C I R C U L A R

Sub:- Providing 7.5 m clear road width on bridges which are initially designed for 6.8 m clear road width.

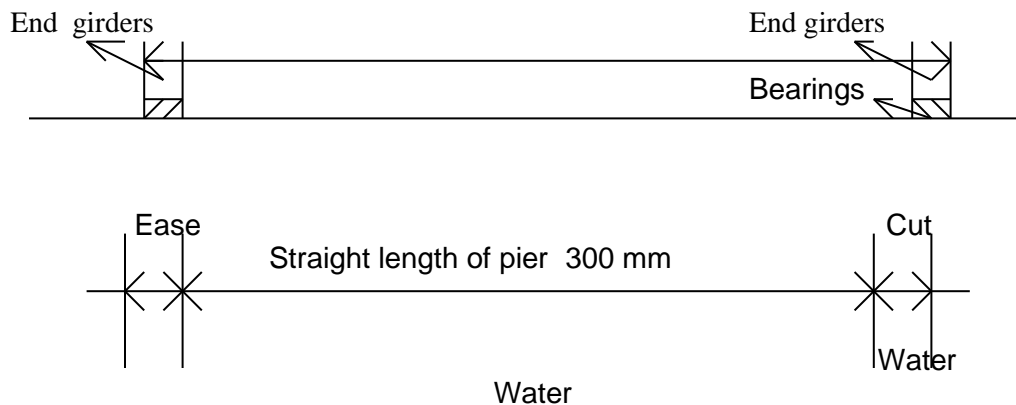
4. For T-beam and slab type bridges, the straight length of the piers should kept as indicated in the sketch below, for superstructure, working drawings should be called for before inviting tenders and quantities of concrete and steel be worked out from these drawings and the same be considered while inviting tenders.

The length of the abutment shall be increased  
From 7.56 m. to 8.25m.
